STAFF REPORT ADDENDUM

APPLICATION
DPA-HM-117-02,
PCA-B-846-03 and
PRC-B-846-04

APPLICANT: RP 11720, LLC

PROPOSAL: To amend the existing development plan DP-117 approved for a convention/ conference center (office) to permit medium density residential to construct 54 single family attached dwelling units, including 5 workforce dwelling units.

SCALE:
 1" = 30'
 SHEET 3 OF 9
 DATE: AUG, 2015
 DRAFT: WOR CHECK: MTT1
 FILE NUMBER: 15057-1-1 3B

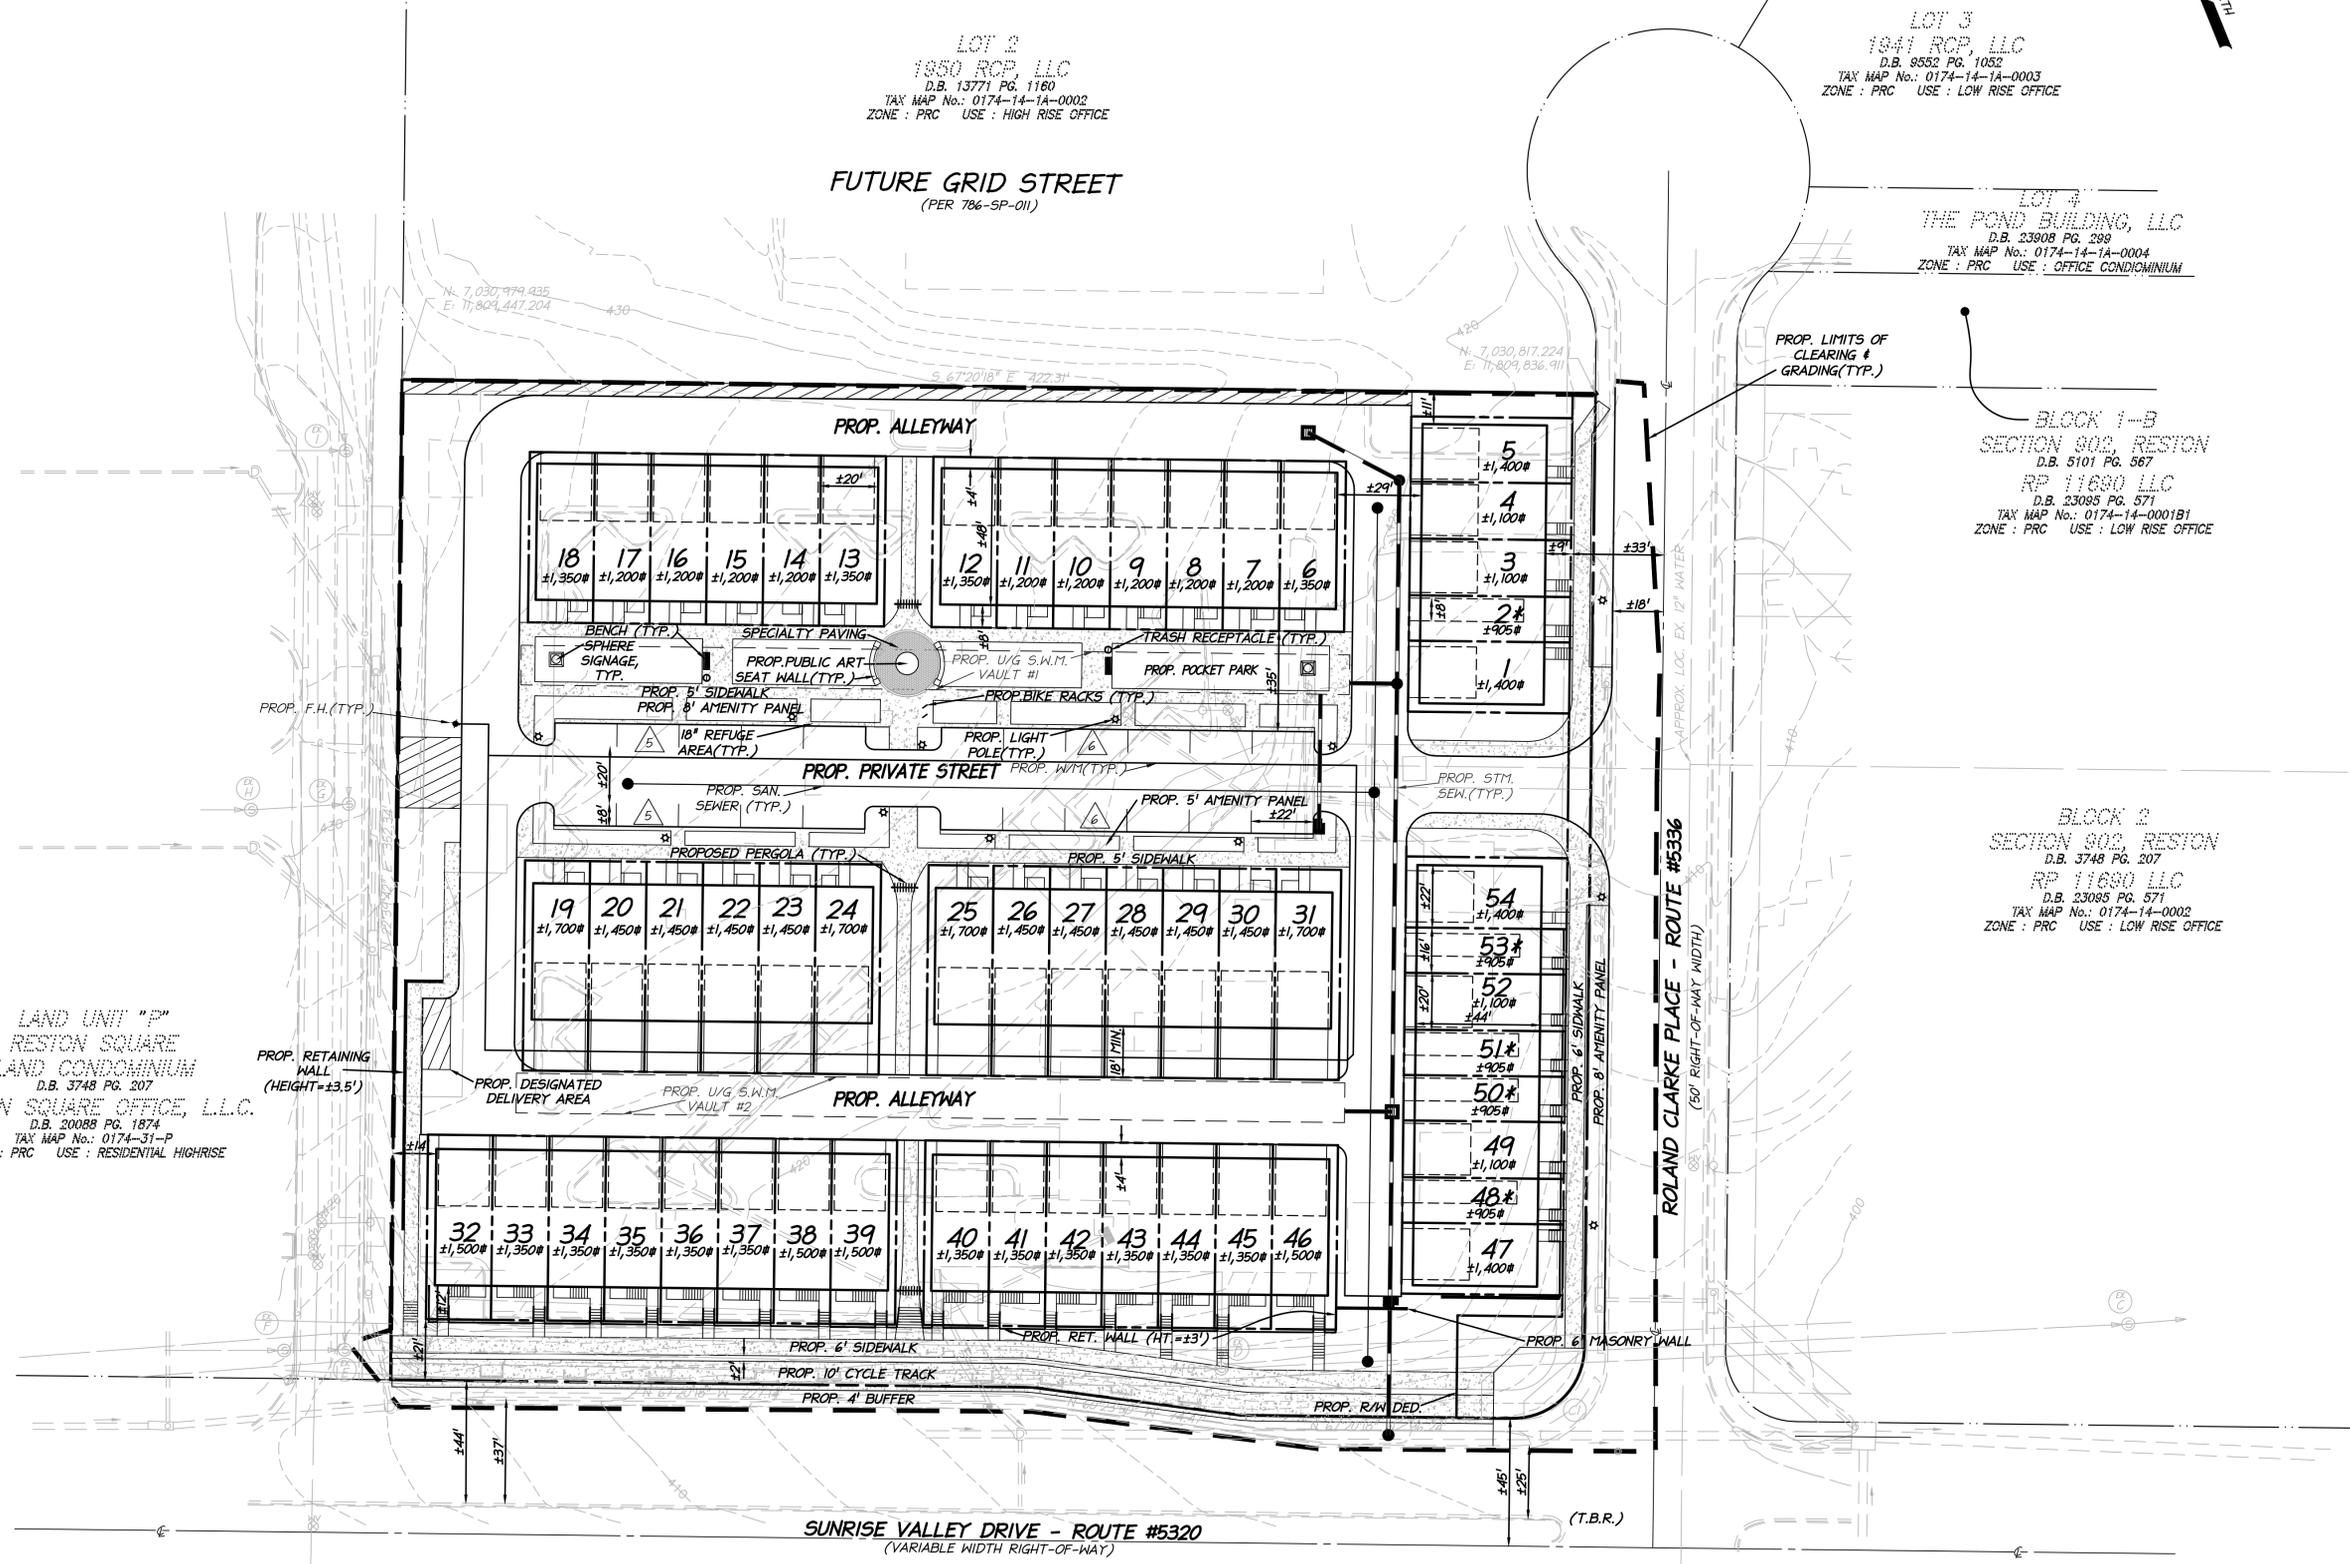
6. As shown on Sheet 3 of the DPA/PRC/PCA, an ingress/egress easement on the western property line shall be included in the land records.
7. The character of the architectural design and building materials for the building shall be in general conformance with the architectural rendering shown on Sheet 7 of the PRC Plan.

Figure 1- Sheet 3 of Revised PRC/DPA/PCA Plan

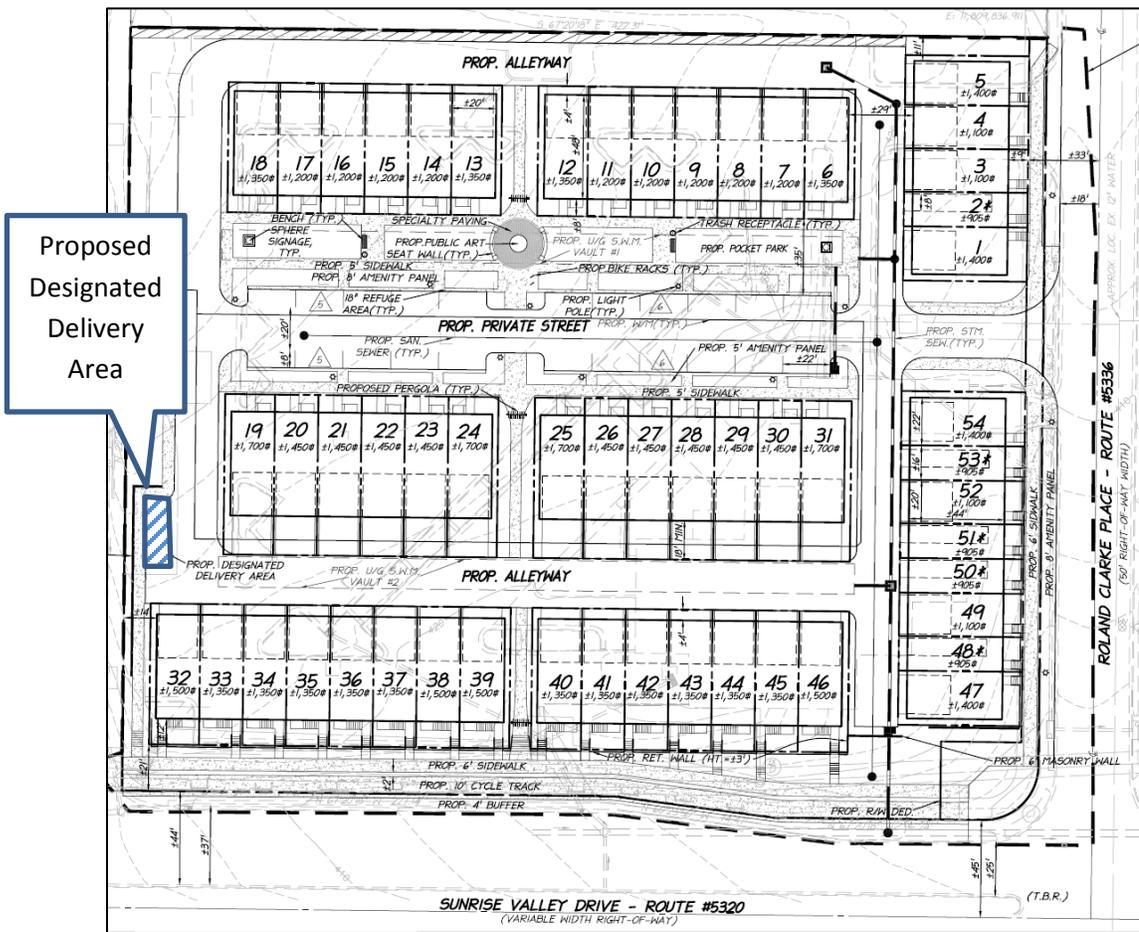
The applicant updated the development plan to outline a Proposed Designated Delivery Area in the southwestern corner of the plan, north of Lot 32. Figure 1 below is an excerpt of the revised PRC Plan with the designated delivery area highlighted.

The Planning Commission raised the issue of where delivery vehicles would park on-site since most driveways were not long enough to accommodate a car and there were limited number of surface parking spaces available. The applicant reviewed the site to determine if a space could be provided that did not interfere with the driveways of the proposed townhouses or the alleyways that have determined to be fire lanes. In accordance with these restrictions, the applicant has proposed one delivery vehicle space on the southwestern corner of the property to the north of Lot 32. Staff notes that on-street parking along the private street and Roland Clarke Place as well as the driveways for Units 19-31 could be used for deliveries.

18. Signage. Signage shall be installed noting the area designated for delivery as shown on Sheet 3 of 9 in the western portion of the Property. Signs shall also be added elsewhere on the Property directing delivery vehicles to this area, the exact location(s) to be determined at site plan review.
